International
Aero Engines

V2500 Propulsion System — Nacelle

NACELLE — POWERPLANT — TRANSLATING SLEEVE, THRUST REVERSER —
MODIFICATION OF — SEAL, THRUST REVERSER — REPLACEMENT OF

V2500-NAC-78-0146

Upper Translating Sleeve Modification (with maximum disbond)
Figure 5 (Sheet 1)

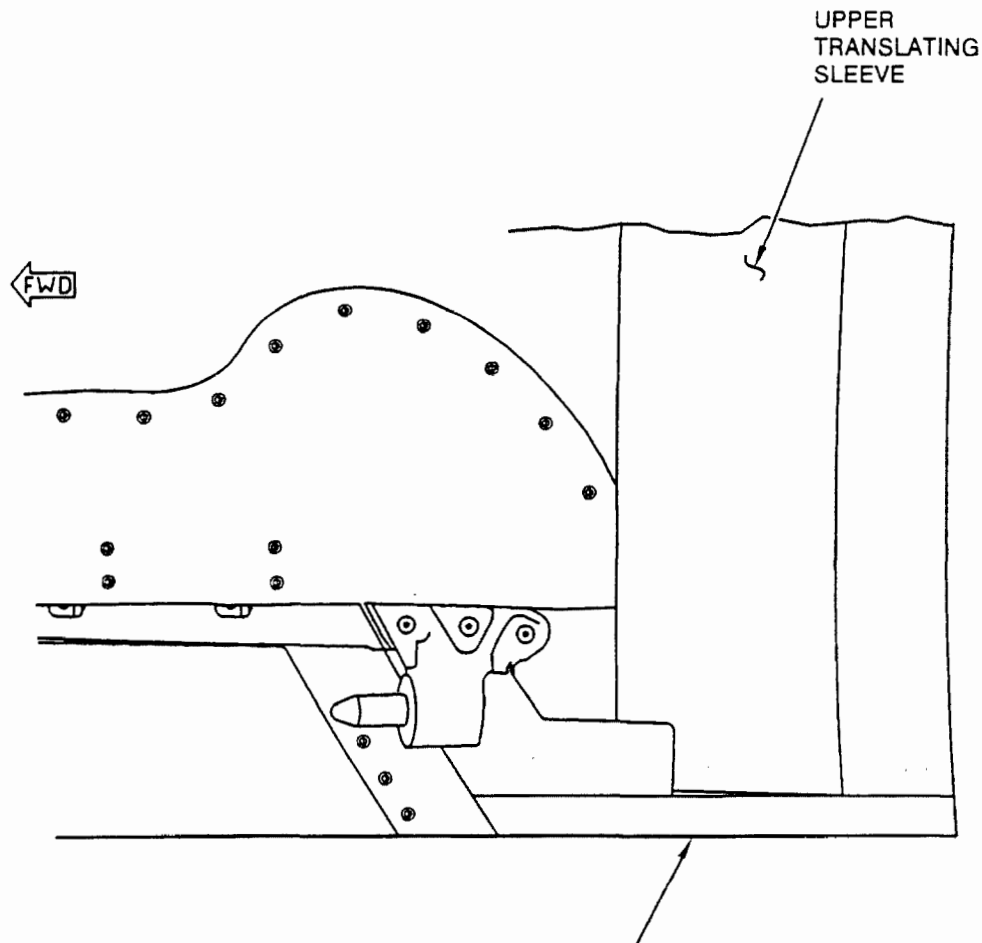
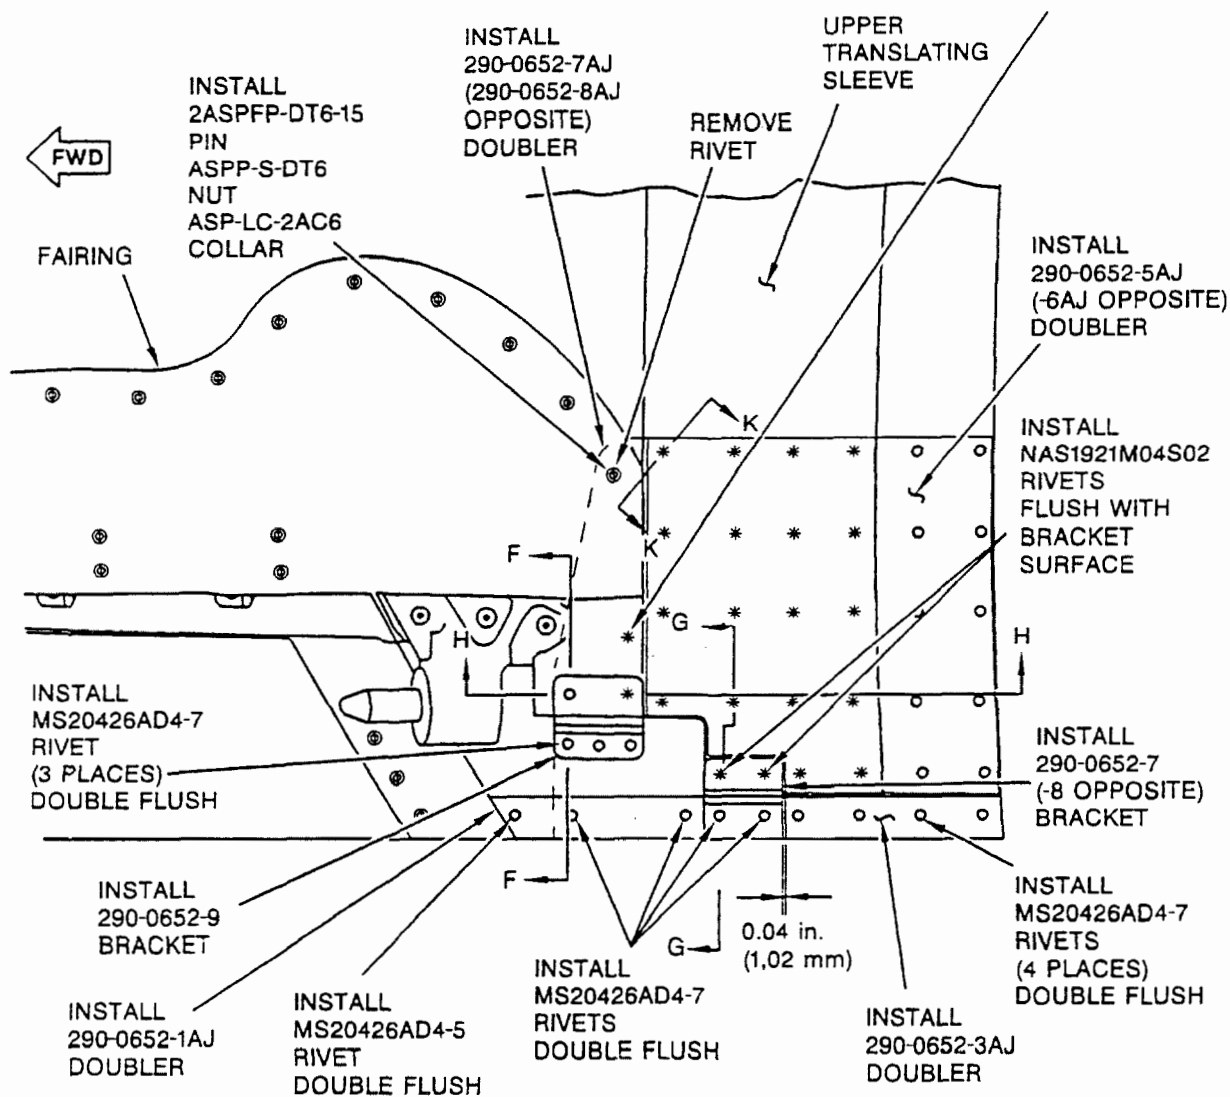
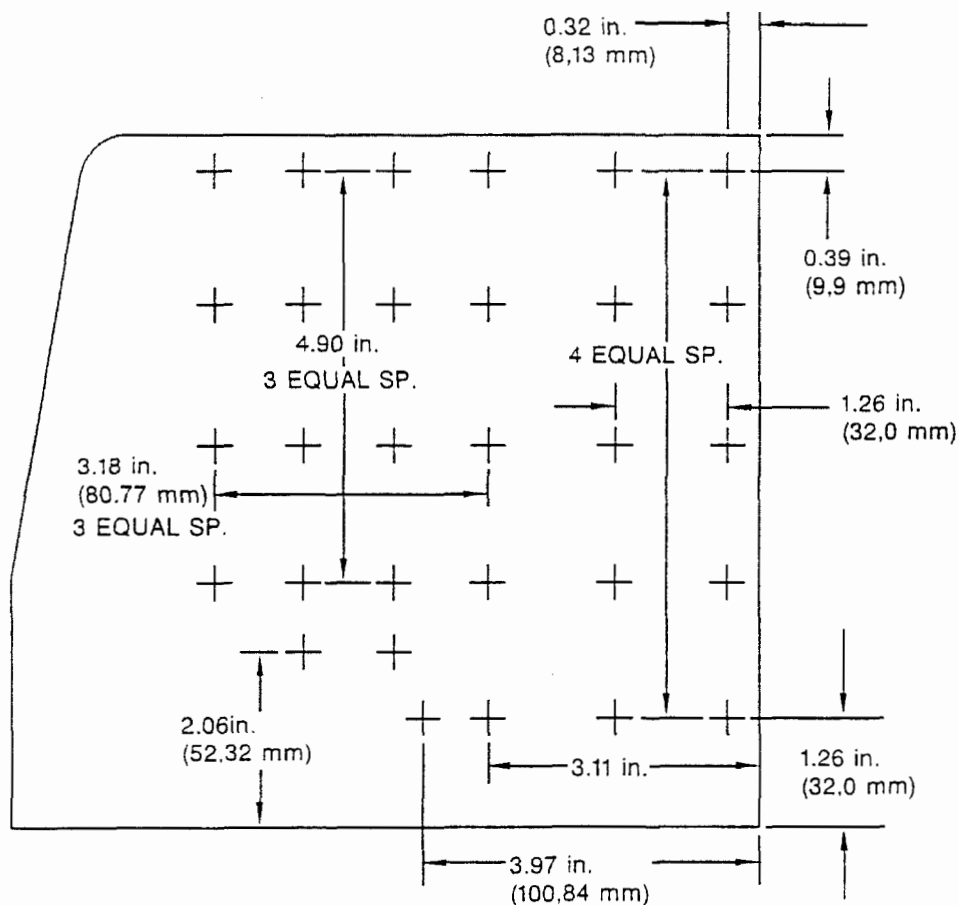
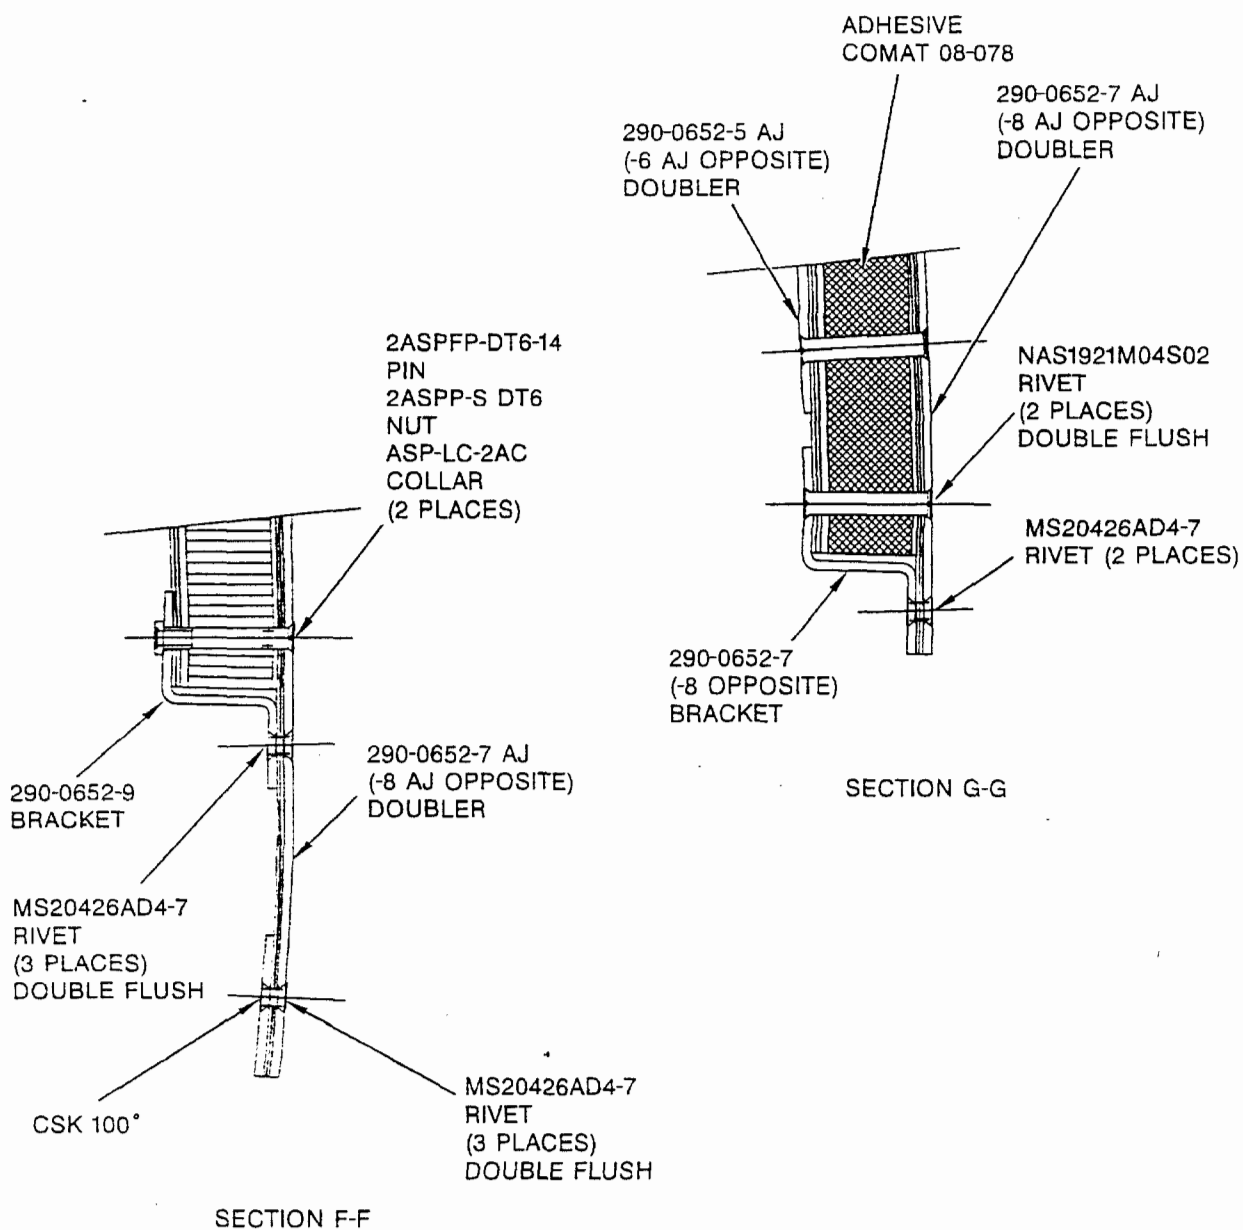
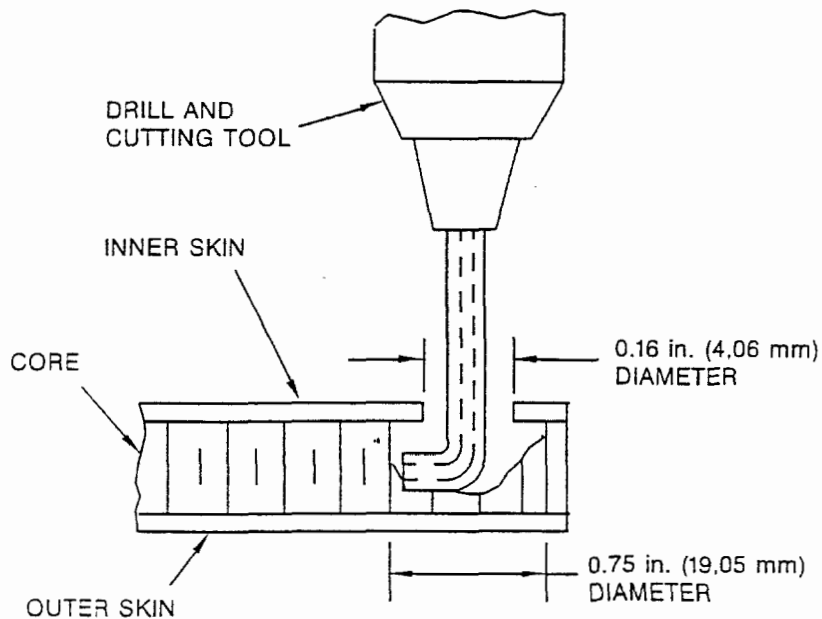
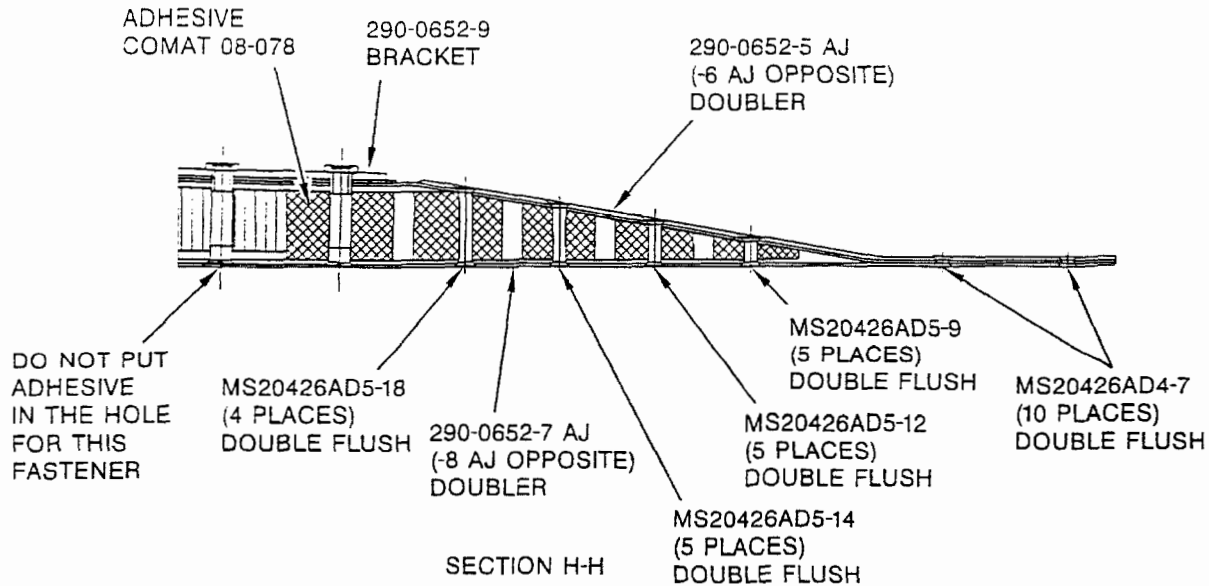
- (1) Remove the bonded rub strip 290-0570-90 (290-0570-91). Refer to Figure 5 (sheet 1).
- (2) Remove one fastener at the aft end of the fairing. Refer to Figure 5 (sheet 2).
- (3) Prepare the fastener holes for the 290-0652-7AJ (290-0652-8AJ) doubler and one fastener hole for the 290-0652-9 bracket. Refer to Figure 5.

- R (a) Hold the 290-0652-7AJ (290-0652-8AJ) doubler in position on the outer skin and drill the 0.125 inch (3.18 mm) diameter holes through the doubler, the outer skin, and the core. Do not drill through the inner skin. Refer to Figure 5.
- R (b) Put the 290-0652-9 bracket into position and make a mark for the aft upper fastener hole.
- R (c) At the position marked in step (b), drill a 0.125 inch (3.18 mm) diameter hole through the inner skin and the core. Do not drill through the outer skin.
- R (d) Remove the core to a diameter of 0.75 inch (19.05 mm) through the holes drilled in steps (a) and (c) at the locations shown in Figure 5 (sheet 3).

- R (4) Put the brackets and doublers into position on the translating sleeve and drill the holes for the fasteners. Refer to Figure 5.
- NOTE:** Some of the brackets and doublers are oversize and must be trimmed after installation.
